REQUEST

Proposed Zoning: MX-2 LWCA (mixed use, Lake Wylie Critical Area) and MX-2 LWPA (mixed use, Lake Wylie Protected Area) with five-year vested rights

Approximately 10 acres located on the west side of Mt. Holly-Huntersville Road, south of Mt. Holly Road. (Outside City Limits)

The petition proposes to allow up to 73 attached dwelling units at a density of 7.3 units per acre, on vacant land adjacent to Catawba Village Shopping Center at the intersection of Mt. Holly-Huntersville Road and Mount Holly Road.

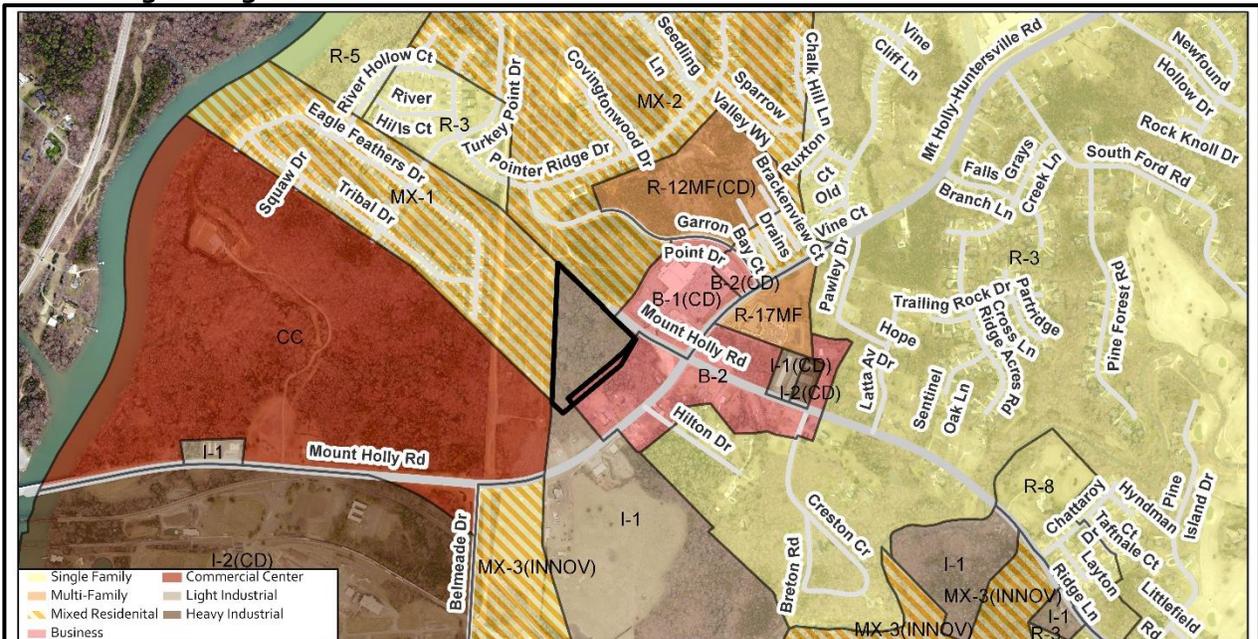
1. Submit a tree survey for all trees two (2) inches in diameter at breast height (DBH) or larger located in the public right of way. Tree survey may be completed by landscape architect, surveyor, or other land development professional.
2. Show and label 30-foot Post-Construction Stormwater Ordinance stream buffers where jurisdictional stream segments have been delineated on the rezoning plan. Please also add the following note: Development within the Post-Construction Stormwater Ordinance stream buffers shall be subject to approval by Charlotte-Mecklenburg Stormwater Services and mitigated if required by City Ordinance.
3. Correct Environmental Features Note 3 to state 15% tree save (not 10%).

4. Modify Architectural Standards Note 6 to state that stoops will be a minimum six feet in depth.
5. Modify Streetscape, Landscaping and Open Space Note 1 to identify minimum amenities to be provided in common open space areas.
6. Remove elevations on sheet RZ-2 if not representative of actual architectural elements.

7. Petitioner needs to clarify if the expectation is that CDOT abandon the 30-foot right-of-way along Mt. Holly Road.
8. Modify General Provisions Note 1 as there is no Sheet CP-1.
9. Modify Permitted Uses Note to indicate only up to 70 attached dwelling units.
10. Numerical order on Sheet RZ-2 is incorrect.
